Wisconsin Department of Transportation

Proposal #37: 8090-00-70, WISC 2018 458
Menomonie - Ridgeland
STH 170 to STH 64
STH 25
Dunn County

8100-01-71, WISC 2018 460
Menomonie - Ridgeland
Hay River Bridge B-17-0225
STH 25
Dunn County

This is Addendum No. 01, which provides for the following:

Addendum No. 01
 ID 8090-00-70
 Revised Sheet 2
 November 5, 2018

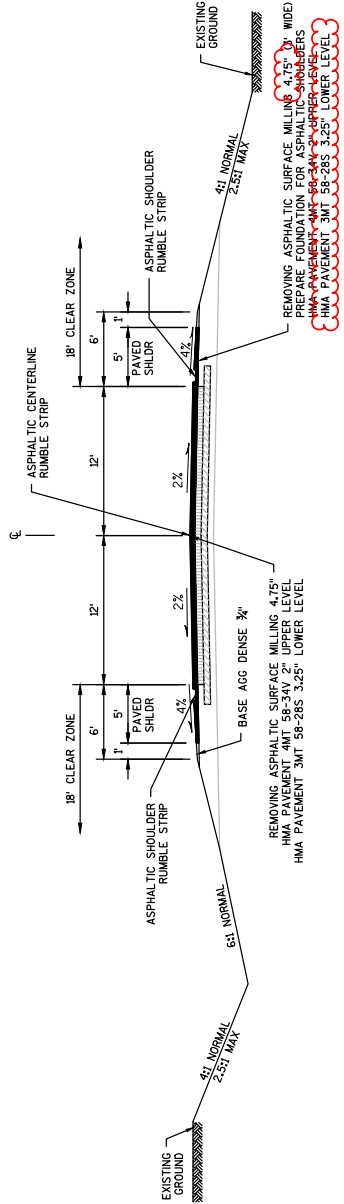
Revised Plan Sheets	
Plan Sheet	Plan Sheet Title (brief description of changes to sheet)
Project 8090-00-70	
2	General Notes: Struck out the 8 th paragraph in the General Notes referring to removed item Asphaltic Surface
4	Typical Sections: Revised milling depth in shoulders, revised paved shoulder lower layer mix type and depth, added note regarding milling or wedging at centerline, added note regarding shaping shoulders to match lower pavement layer
5	Typical Sections: Revised milling depth in shoulders, revised paved shoulder lower layer mix type and depth, added note regarding milling or wedging at centerline, added note regarding shaping shoulders to match lower pavement layer
6	Construction Details: Revised paved driveway details to use HMA 4MT rather than deleted item Asphaltic Surface
7	Construction Details: Revised lower layer in butt joint details to HMA 3MT rather than deleted item Asphaltic Surface

Addendum No. 01
 ID 8090-00-70
 Revised Sheet 4
 November 5, 2018

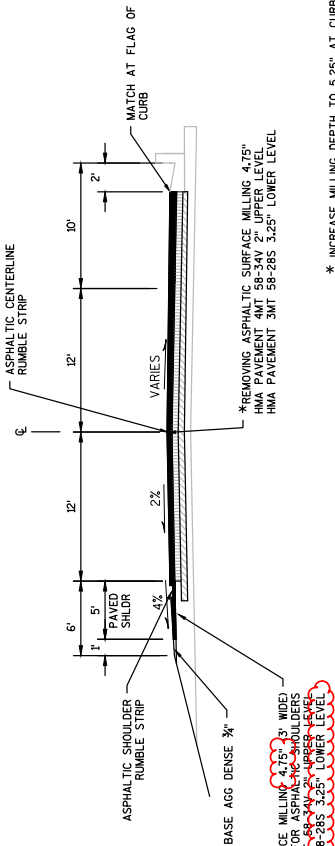
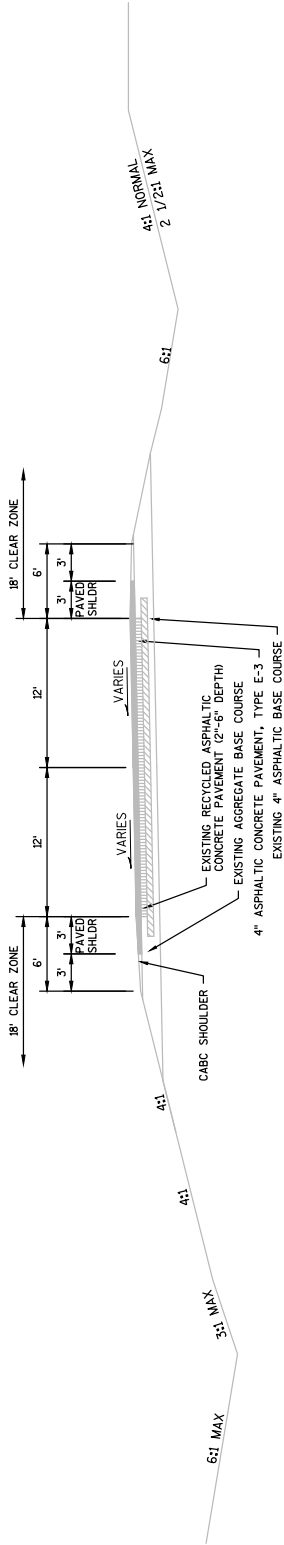
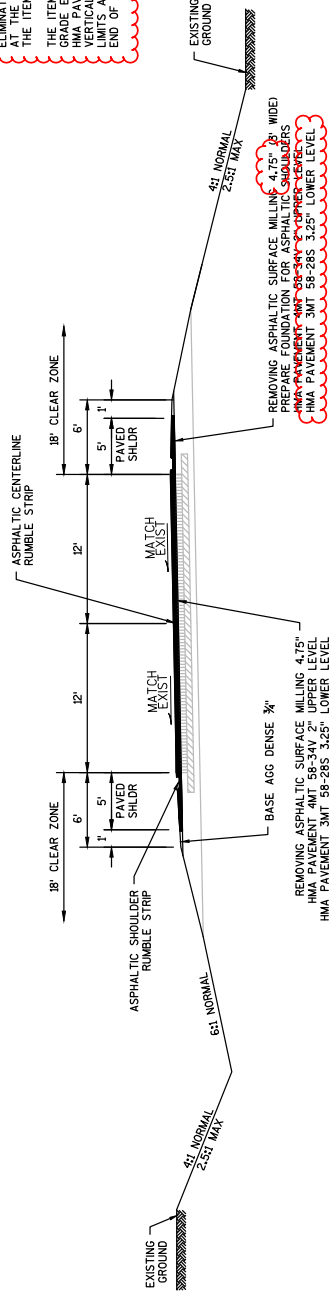
* INCREASE MILLING DEPTH TO 5.25\"/>

Addendum No. 01
 ID 8090-00-70
 Revised Sheet 8
 November 5, 2018

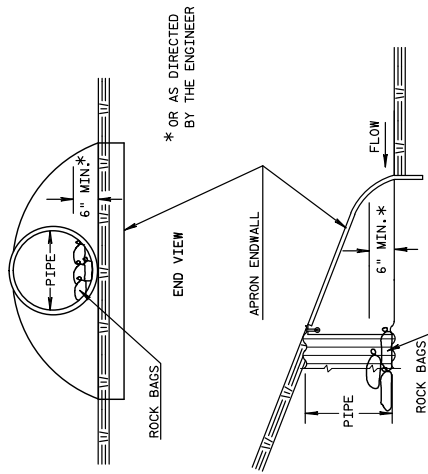
8	Construction Details: Revised HMA depth along guardrail to 5.25"
32	Miscellaneous Quantities: Struck table for removed item Asphaltic Surface, revised HMA 3 MT table to account for increased shoulder depth, added driveway flare quantity to HMA 5MT table
34	Miscellaneous Quantities: Revised 649.0105 item quantity and added notes regarding temporary and same day marking placement
37	Miscellaneous Quantities: Revised PWL table
38	Miscellaneous Quantities: Struck table for removed item Asphaltic Surface, added table for HMA 3MT
Project 8100-01-71	
2	General Notes: Revised paragraph 12 in the General Notes to update the pavement types and depths
3	Typical Sections: Revised HMA pavement depths for upper and lower layers and changed upper layer to HMA Pavement 4MT
14	Miscellaneous Quantities: Updated the HMA 3MT table quantities and changed to HMA 5MT table to HMA 4MT and updated quantities
